Foursquare at Sterling Ranch PUDSP Amendment (Sterling Ranch East Fil 8) 1st amendment
File Number PUDSP256 Must be recorded to continue processing the 2nd amendment. Please obtain the Mylar w signatures for recording.

STERLING RANCH EAST FILING NO. 8

PUD DEVELOPMENT PLAN AND PRELIMINARY PLAN

STERLING RANCH EAST FILING NO. 8
(~~FOURSQUARE~~ 2cd amendment ~~1 AMENDMENT~~)
PUD DEVELOPMENT PLAN & PRELIMINARY PLAN
TITLE SHEET

KEY MAP
SCALE: 1"=200'

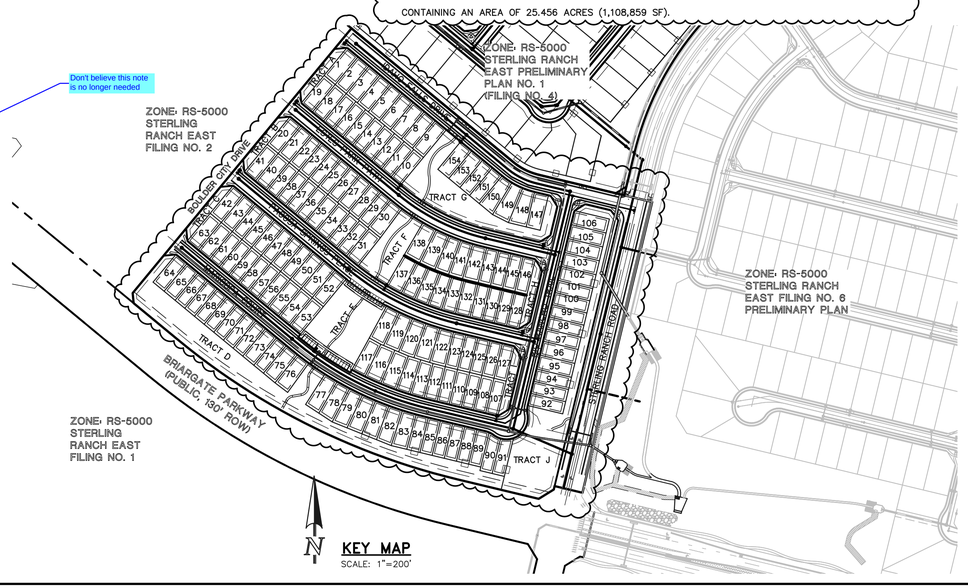
remove this cloud- this was amended w first amendment

GEOLOGY/ENGINEERING GEOLOGY MAP
prepared by ENTECH, dated August 27, 2025

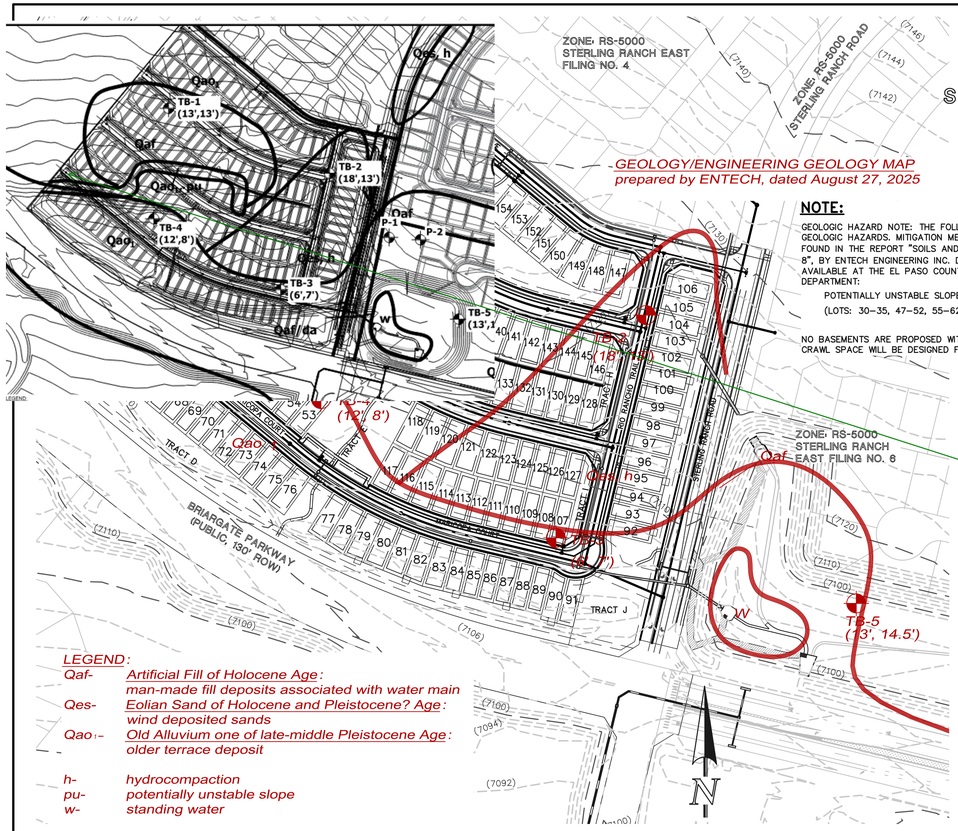
these were the old lot numbers with first amendment please update

update per new report and CGS comments

6' SCREEN WALL DETAIL

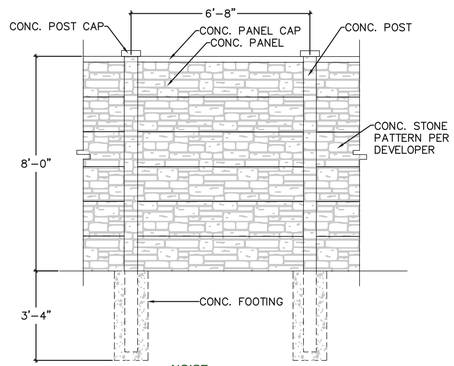
noise wall installed by developer and maintained by district - please add note

DESIGNED BY	KES	SCALE		DATE	07/17/2026
DRAWN BY	KES	(H) 1"= 30'		SHEET	4 OF 18
CHECKED BY		(V) 1"= N/A		JOB NO.	1183.28

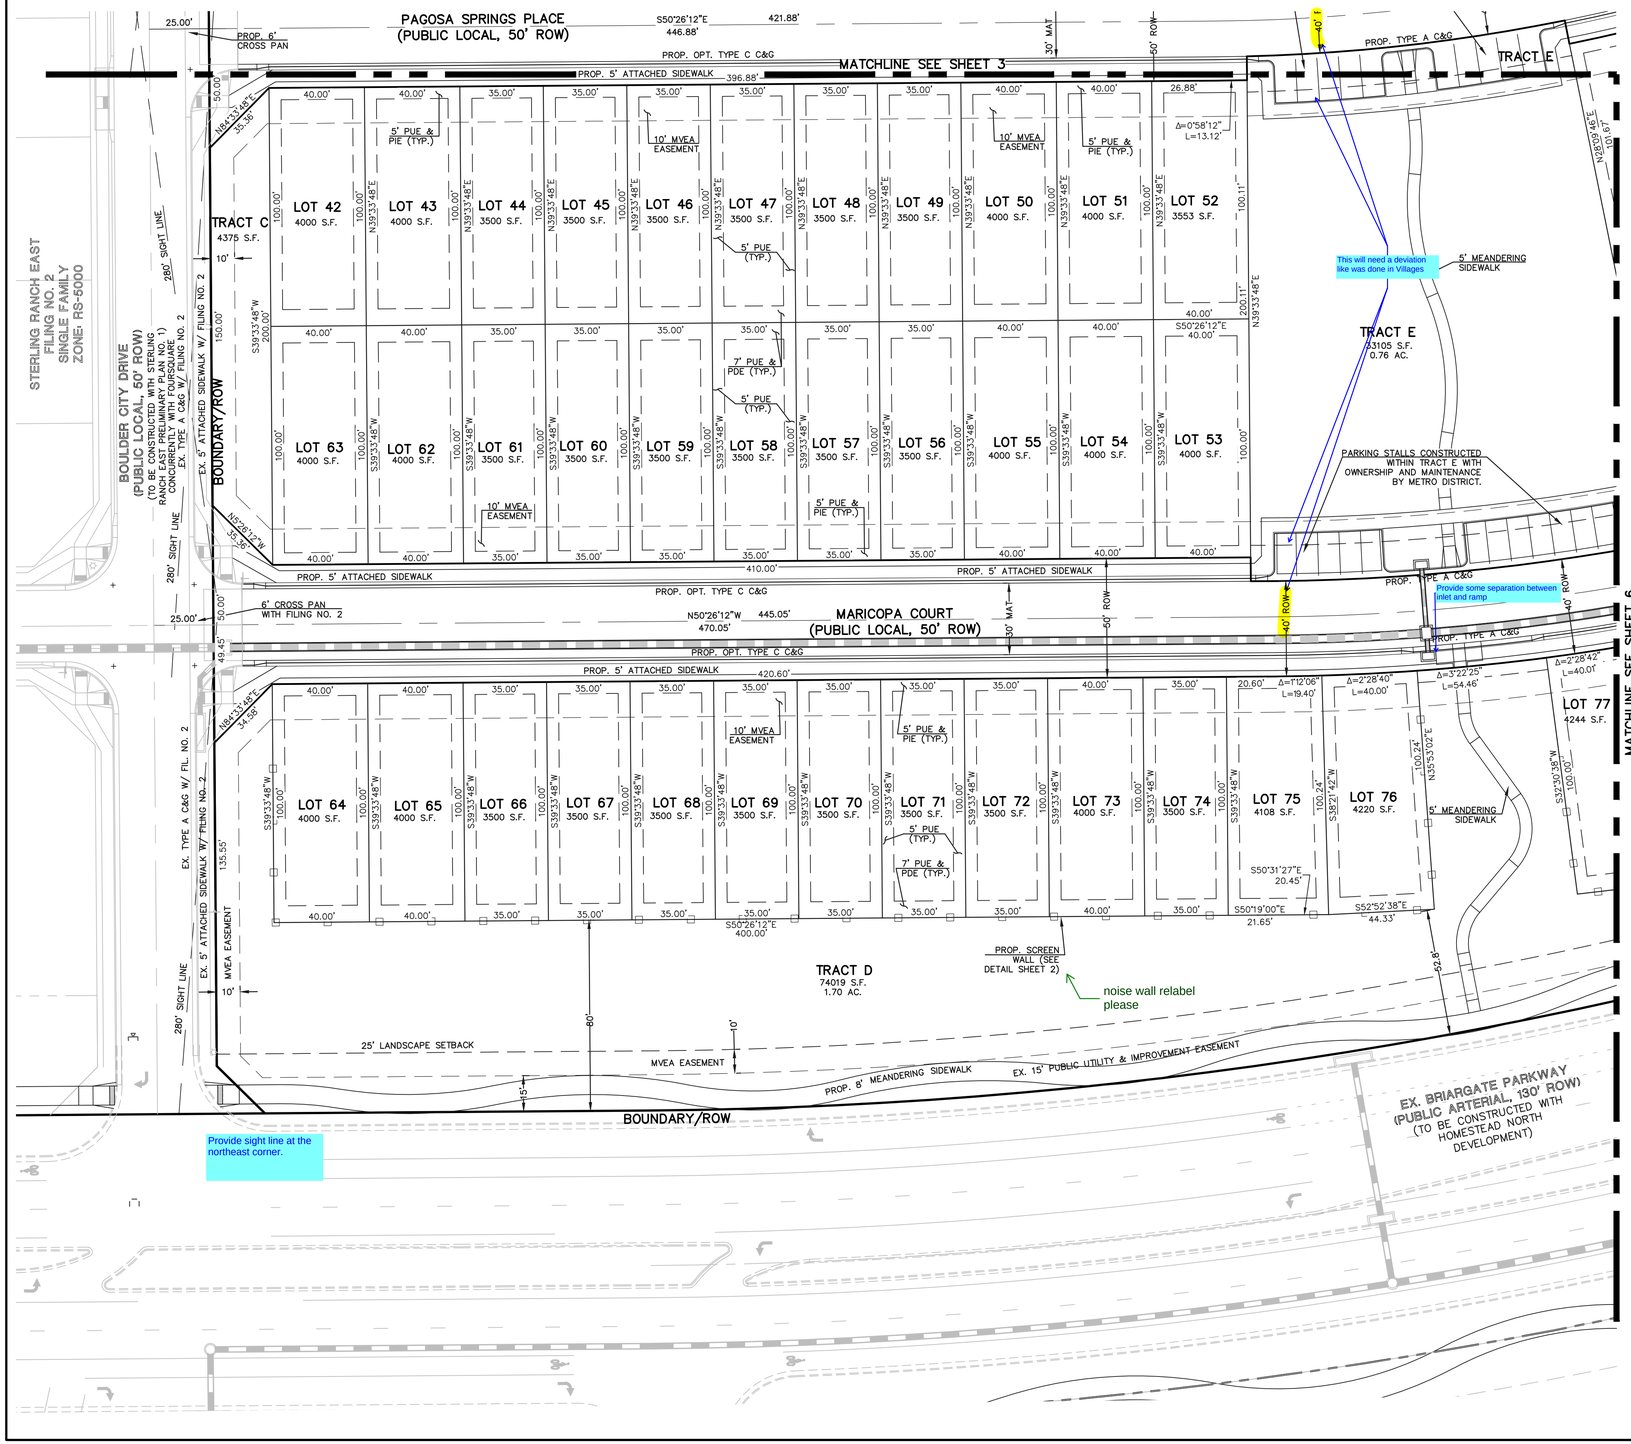
the match line nees to move west so we have lots 150, 140, whole on at least one sheet

thses lots need to be whole on a sheet

Per ECM section 2.5.2.C.4 pedestrian ramps should not be more than 600 ft apart. Please add mid block crossing if distance between shown ramps is over 600 ft. (Both sides of road)

DESIGNED BY	KES	SCALE	DATE 07/17/2026
DRAWN BY	KES	(H) 1"= 30'	SHEET 5 OF 18
CHECKED BY		(V) 1"= N/A	JOB NO. 1183.28

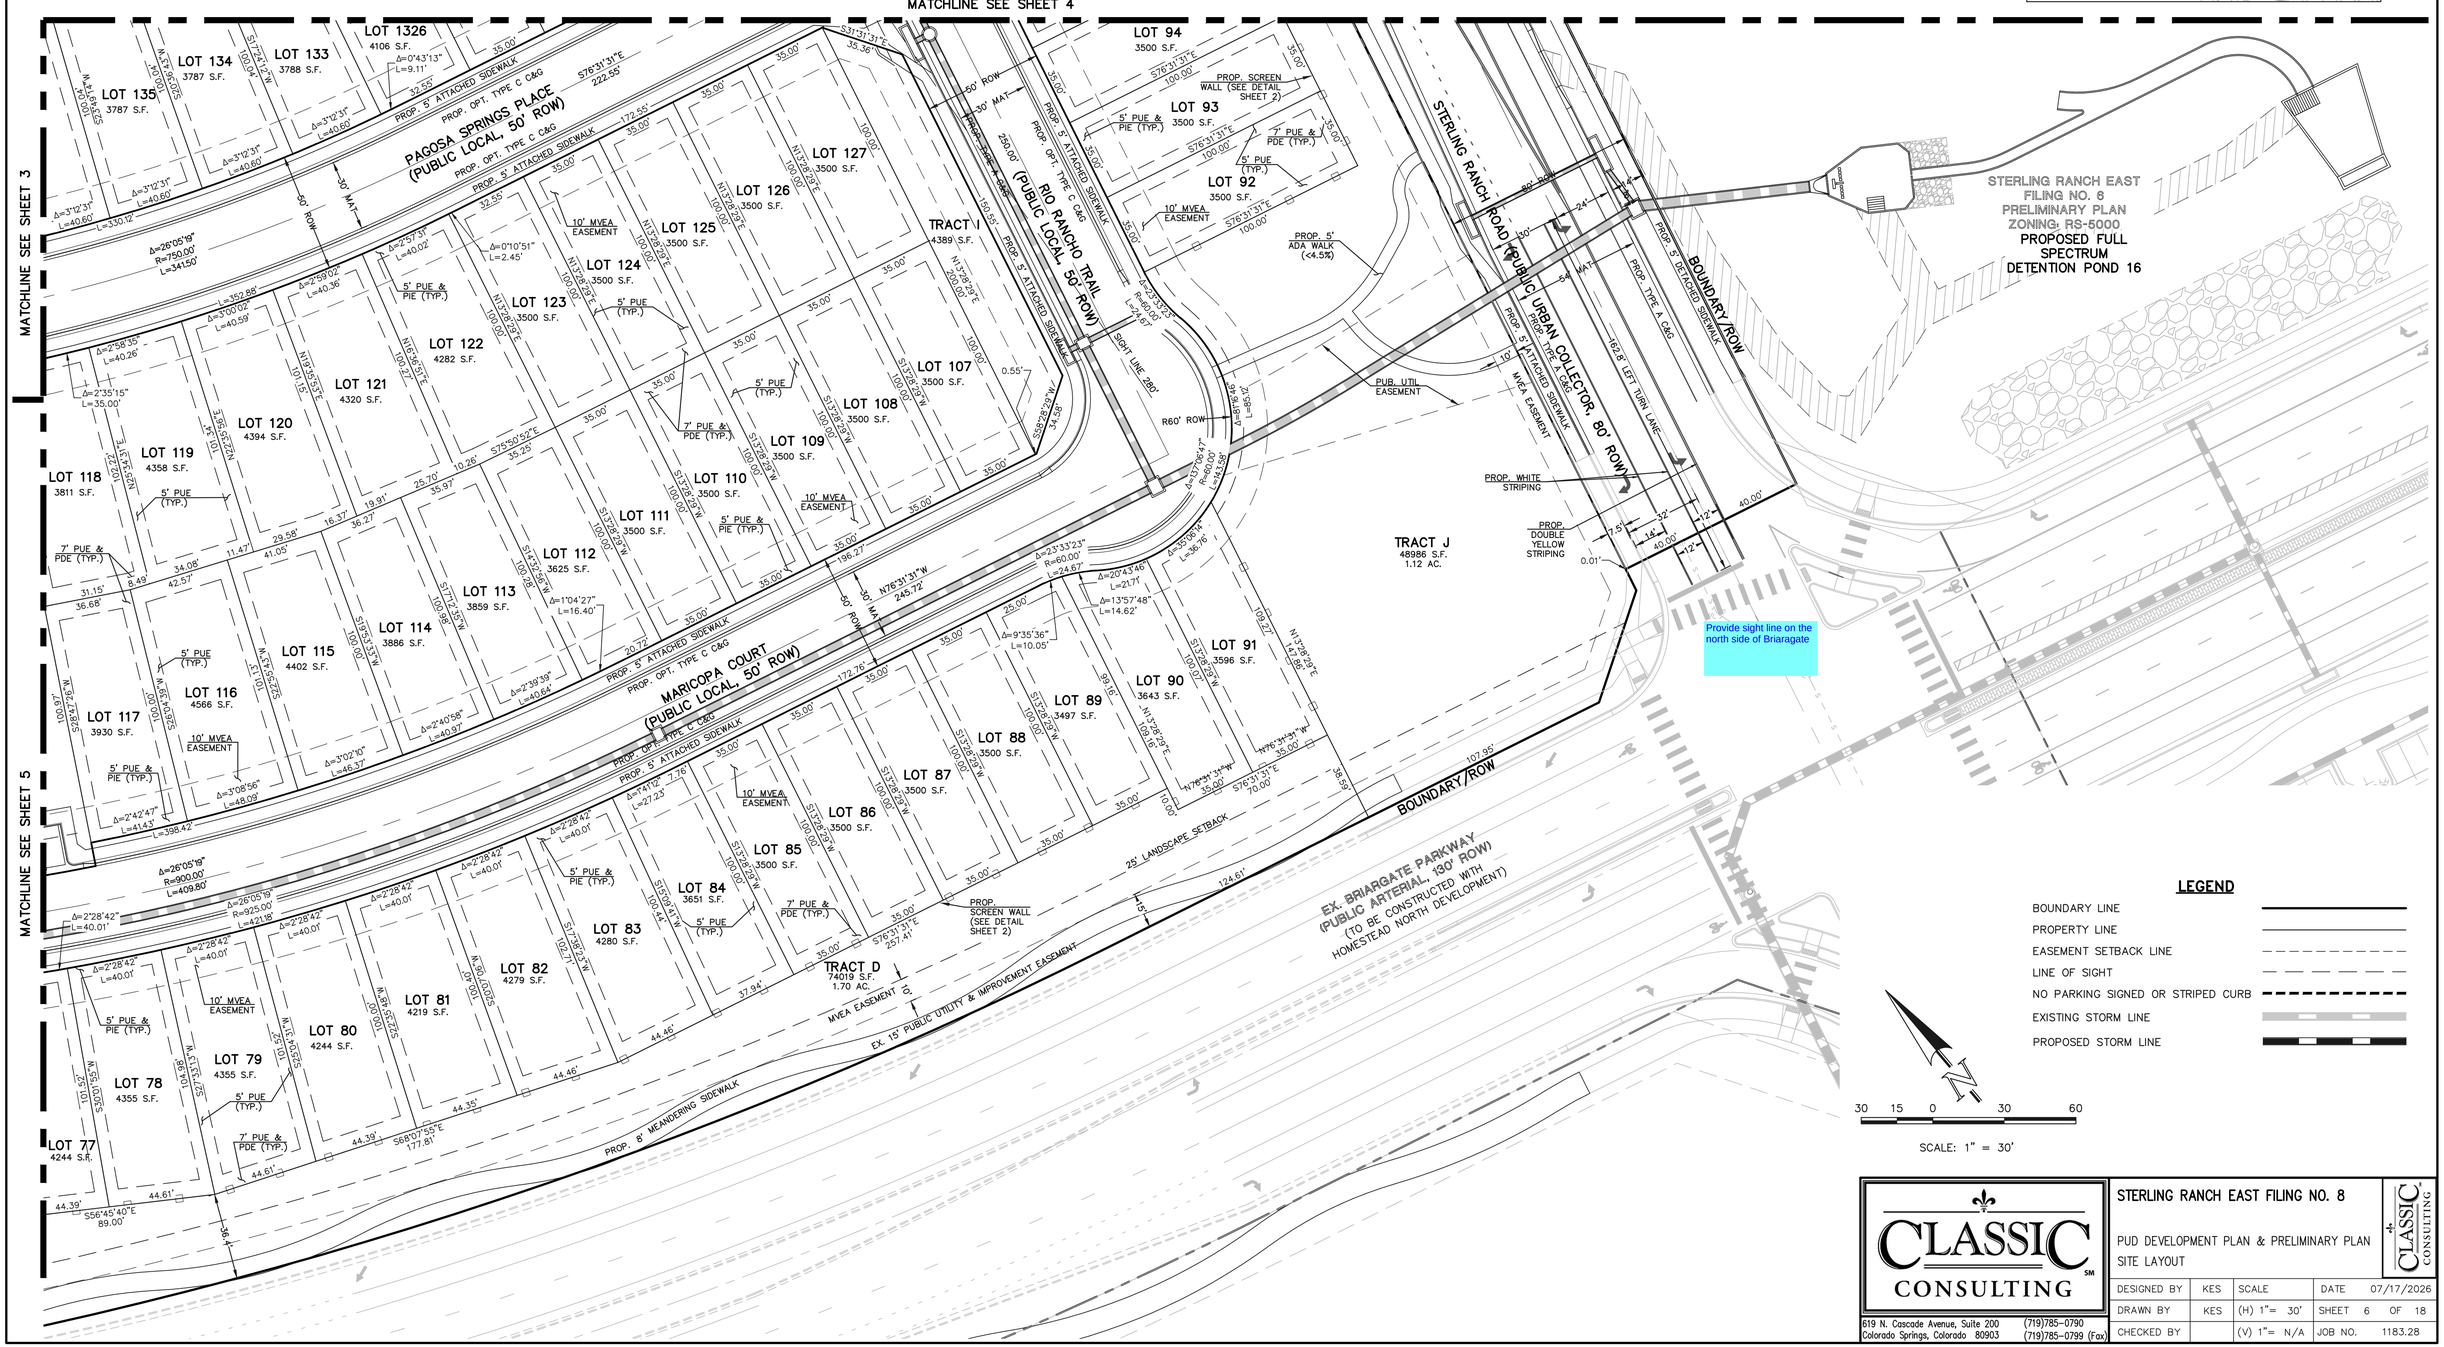
Provide sight line at the northeast corner.

This will need a deviation like was done in Villages

Provide some separation between inlet and ramp

DESIGNED BY	KES	SCALE		DATE	07/17/2026
DRAWN BY	KES	(H) 1"= 30'		SHEET	6 OF 18
CHECKED BY		(V) 1"= N/A		JOB NO.	1183.28

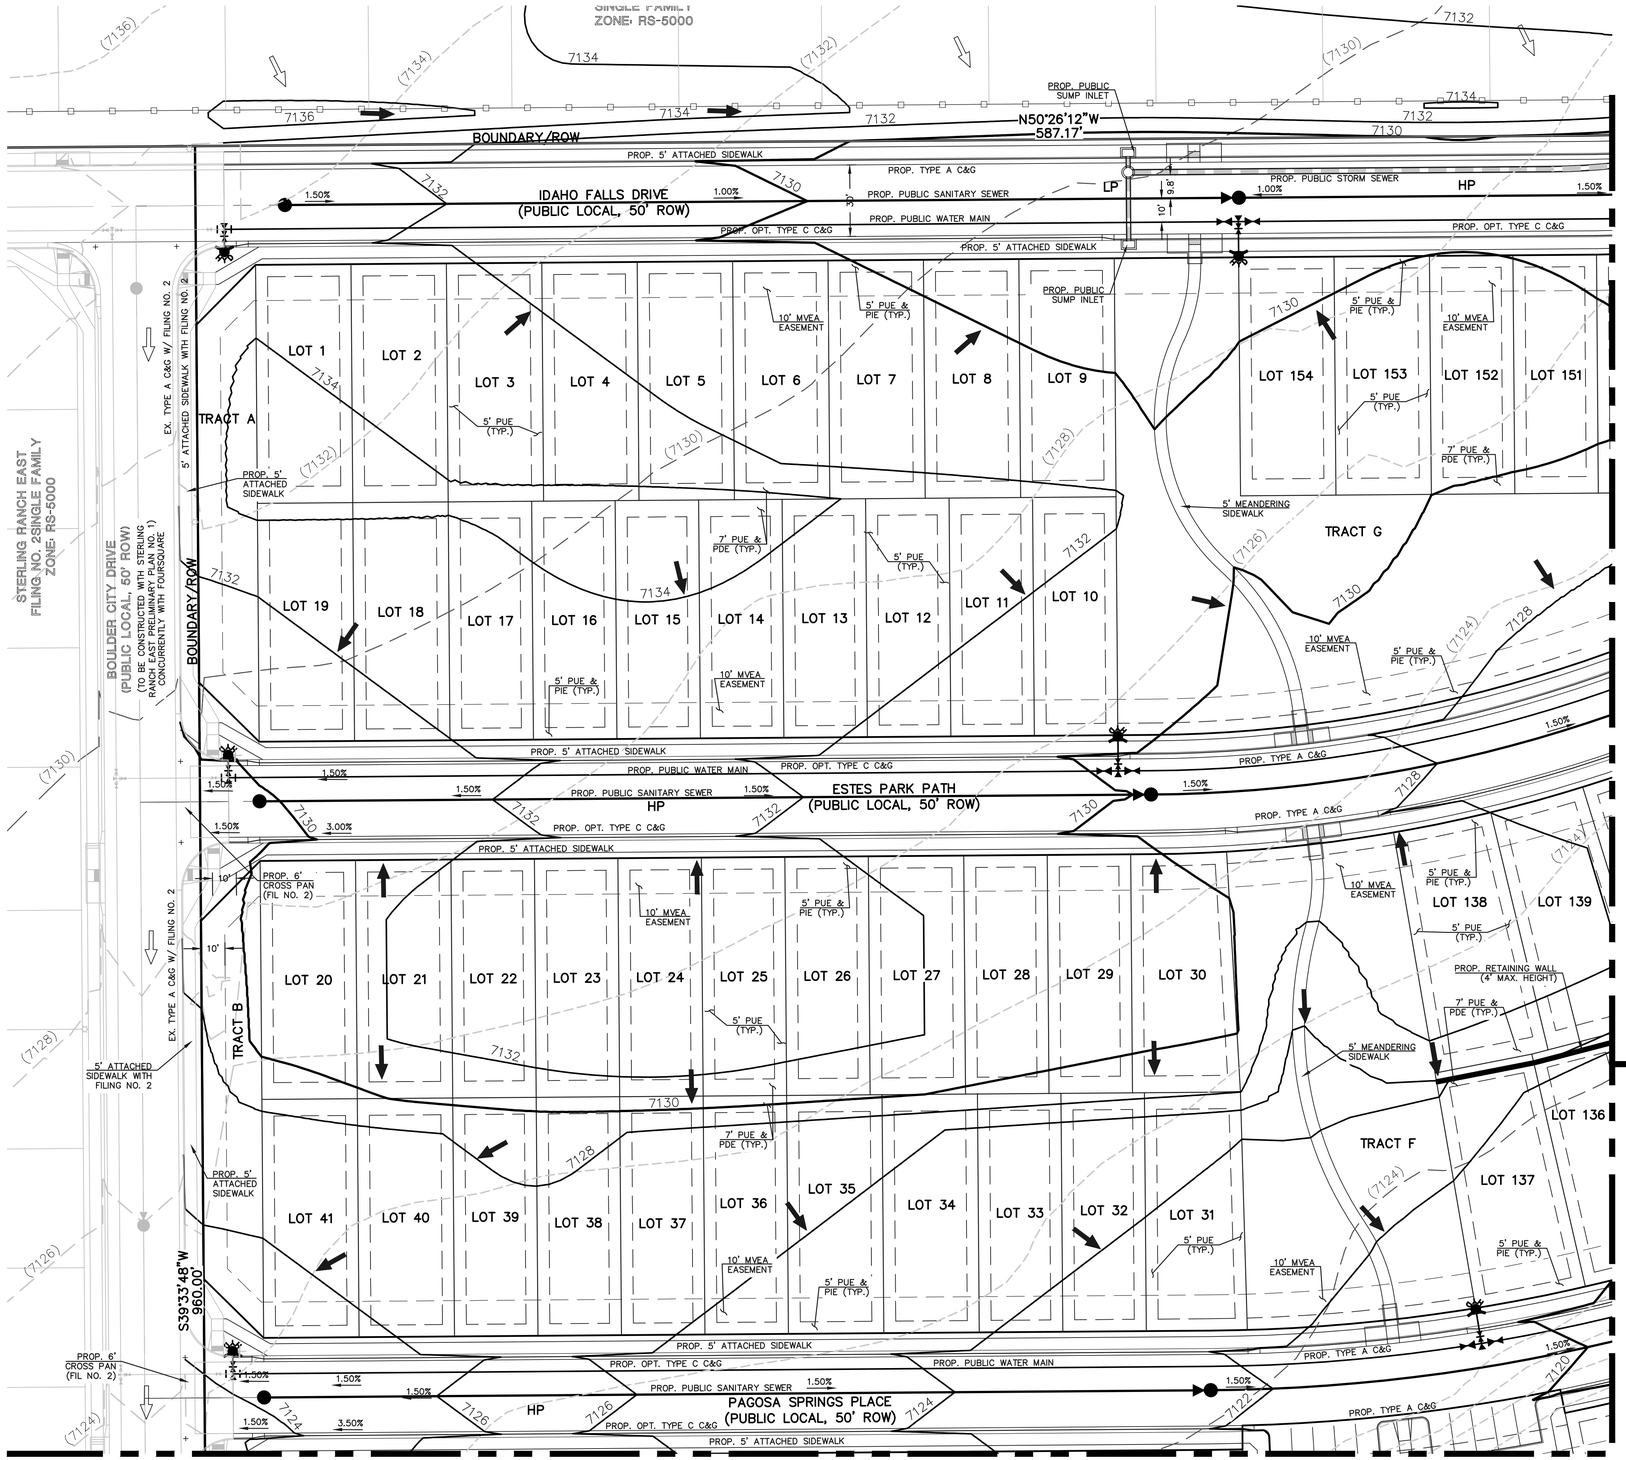
Provide sight line on the north side of Briaragate
